No. 0994
ATA Code 27-30

SUBJECT: FLIGHT CONTROLS - INSPECTION OF THE STABILATOR TRIM TAB ACTUATOR ROD

EFFECTIVITY: BEECHCRAFT B19 Sport 150, serials MB-558 through MB-886;
C23 Sundowner 180, serials M-1413, M-1414, M-1416 through M-1418, M-1420 through M-1422, M-1424 through M-1438, M-1440 through M-1446, M-1448 through M-2009, M-2011 through M-2015 and M-2017 through M-2020;
B24R and C24R Sierra 200, serials MC-151 through MC-559, MC-561 through MC-563, MC-565 through MC-568 and MC-571.

REASON: To inspect the stabilator trim tab actuator rod and clevis for proper rivet location and rework if necessary.

Figure 1.

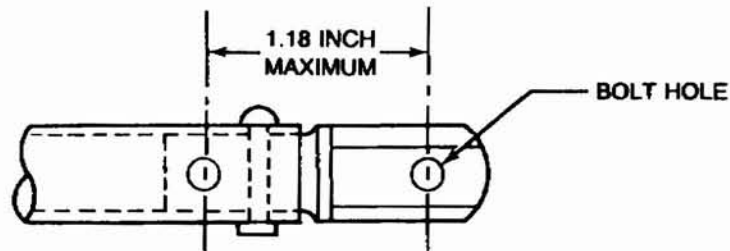
1. On both ends of the rod, measure the distance from the center of the bolt hole through the clevis to the center of the second rivet through the rod and clevis (see figure 1.)

2. If the measurement taken in step 1 exceeds 1.18 inches on either end of the rod it will be necessary to rework the rod, continue with step 3. If the measurement is 1.18 inches or less on both ends no rework is necessary, omit steps 3 through 9.
3. Tag the actuator rod to ensure that it will be reinstalled in the same position after rework.
4. Remove the cotter pins, nuts, washers and bolts from both ends of the actuator rod and remove the rod through the slot in the aft end of the tail cone.

Figure 2.

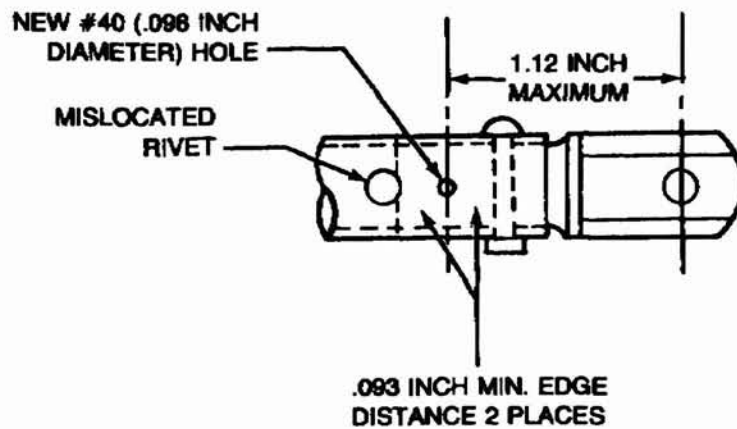
5. If one rivet in the actuator rod is improperly located check the other rivet to make sure it is tight. If the rivet is loose replace it with a new MS20470AD3 rivet of appropriate length only after completing steps 6 and 7 of these Service Instructions.
6. Drill a #40 (.098 inch diameter) hole centered not more than 1.12 inches from the center of the bolt hole. Maintain at least a .093 inch edge distance from either existing rivet (see figure 2.).

7. Install a MS20470AD3 rivet of appropriate length through the new hole in the rod and clevis.
8. If necessary repeat steps 5 through 7 on the other end of the rod.
9. Reinstall the actuator rod in its original position through the slot in the aft end of the tail cone. Reinstall the bolts, washers, nuts and new AN380 cotter pins. If the trim tab actuator shaft has not been turned it should not be necessary to rereg the trim tab.
10. Reinstall any access panels removed to accomplish these Service Instructions.
